Service Bulletin

No. : MZ08-023

Model: SR7002, SR8002

Subject: Software Update Information

Add a shield wire to the two points where the pattern has been cut on POS. NO. 56 HDMI PWB.

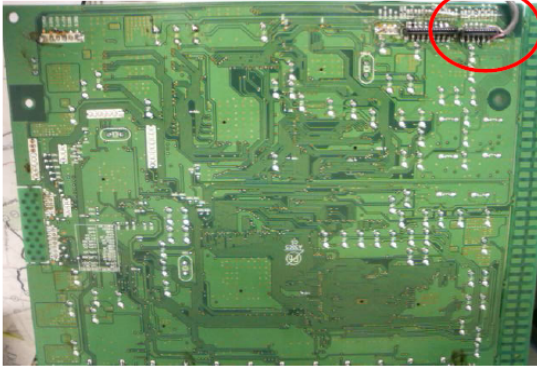
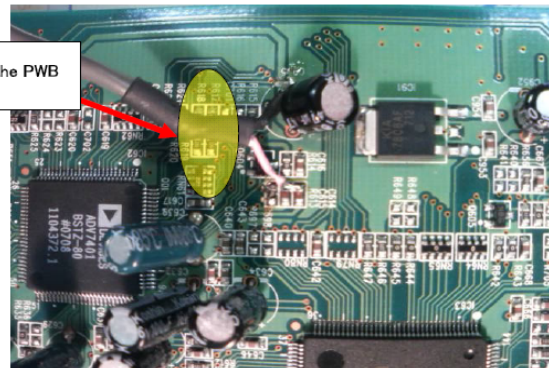
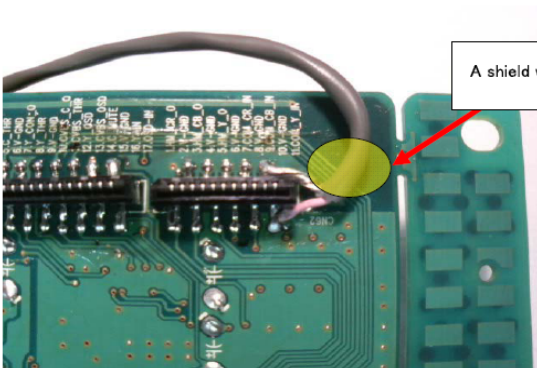
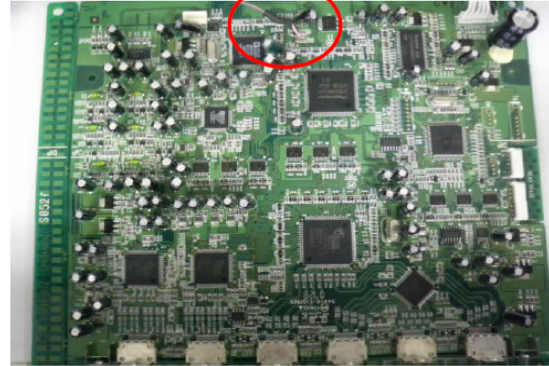
Symptom: 1. The SW LEVEL drops when the ACCOUSTIC EQ MODE is switched ON.
2. When the product is playing back Dolby TrueHD/dts-HD Master Audio, the audio becomes choppy or noisy at intervals of a few minutes to more. (This problem occurs only when the product is connected to a Blu-ray/HD DVD Player via HDMI, with the player outputting TrueHD/Master Audio Bitstream and the TrueHD/Master Audio decoded in the SR; it never occurs when the audio is decoded in the Player and sent via HDMI in multichannel PCM. It never occurs to the Dolby Digital Plus/dts-HD High Resolution Audio.)
3. When the audio signal is changed from Analog Component (720p, 1080i) to HDMI, vertical fringes appear on the left side of the TV screen.
4. When the audio signal is changed from Analog Component (480p) to HDMI, vertical fringes appear on the left side of the TV screen.

1. It is connected by a shield wire from CN62 to R613 then bond to the PWB.

BOND: SONY Chemical SC608LVZ Sony Chemical Corp. Self-extinguishing adhesive) or the equivalent.
2. points of pattern out.
